REQUEST

Current Zoning: N1-A (Neighborhood 1-A)
Proposed Zoning: N2-A(CD) (Neighborhood 2-A, Conditional)

SUMMARY OF PETITION

OUTSTANDING ISSUES PRIOR TO PUBLIC HEARING

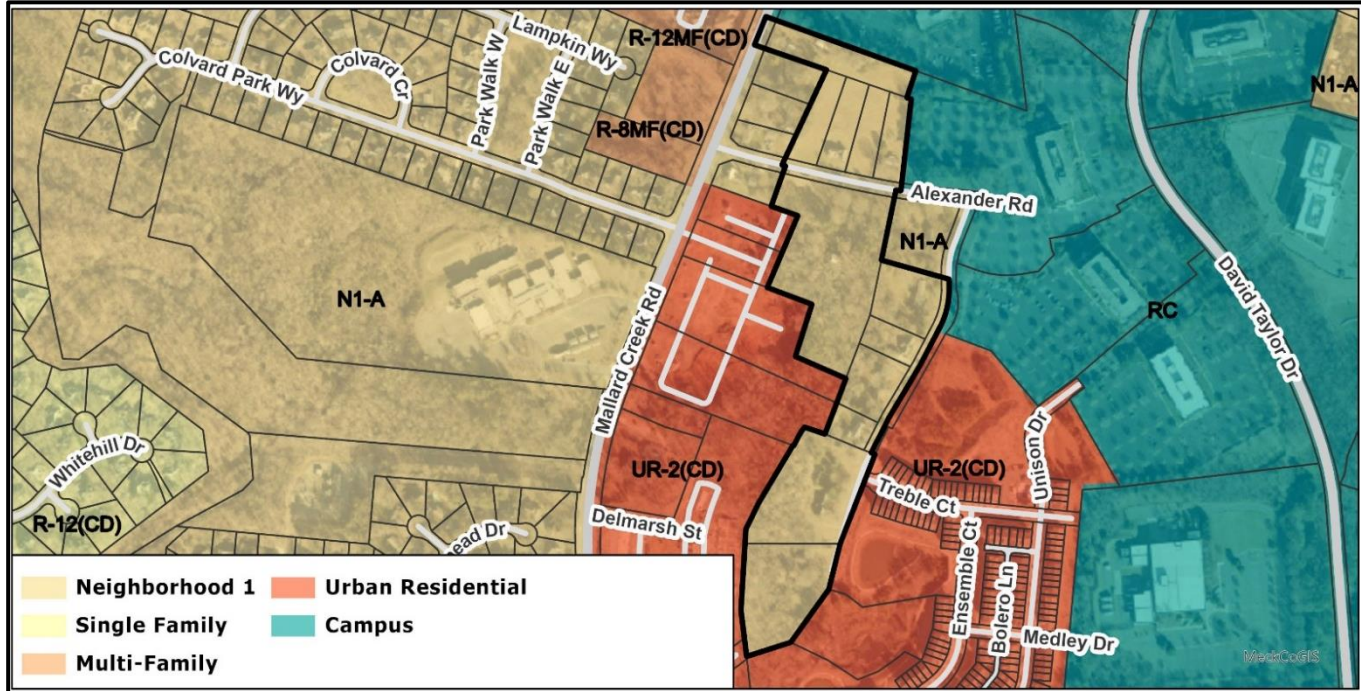
1. Revise roadway callouts to be U-03 and not U-03A1. U-03A1 is simply one part of the overall layout of U-03 while U-03 describes all of the U-03 cross sections required for this site.

2. Revise roadway callouts to be U-03 and not U-03A1. U-03A1 is simply one part of the overall layout of U-03 while U-03 describes all of the U-03 cross sections required for this site.

3. Add proposed ROW dimensions to the site plan for College View Lane and Alexander Road. Ensure ROW is dimensioned in relation to the roadway centerline.

4. Revise site plan by revising callout to say final design of Treble Court connection to College View Lane to be coordinated during permitting.
5. Revise roadway identifier on the site plan to callout roadway as proposed, due to this not currently existing.

6. The existing R/W does not exist connecting to Silver Branch road. Label that the R/W and street will be constructed and improved along the entire project boundary.

7. Label the 8' sidewalk and 8' planting strip on all public streets. Label the centerline and the distance from centerline to 2' behind the sidewalk as R/W.

8. Ensure that tree save meets all standard. Tree save has a 10' no build zone around it and does not permit sidewalks within tree save.
9. Some areas shown as tree save do not have any trees. Adjust tree save areas to include existing canopy.

10. Clarify the provided seating requirements for public open space.
